Change Statement

testo Saveris 2 product use GT202 Wifi module. This module can support both internal PCB antenna and also external antenna through IPEX connector. In original design, our company use internal PCB antenna, now change to use external antenna through IPEX connector. Antenna type is 2.4G copper tube antenna-1.13 grey - IPEX -L55MM. Manufacturer is Shenzhen FLY Electronic Co., Ltd. Here we confirm that no any change in other design.

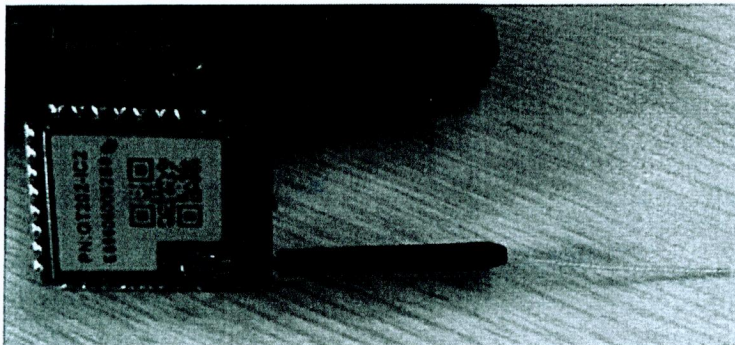
Below pictures show before change and after change:
Before change:

After change:
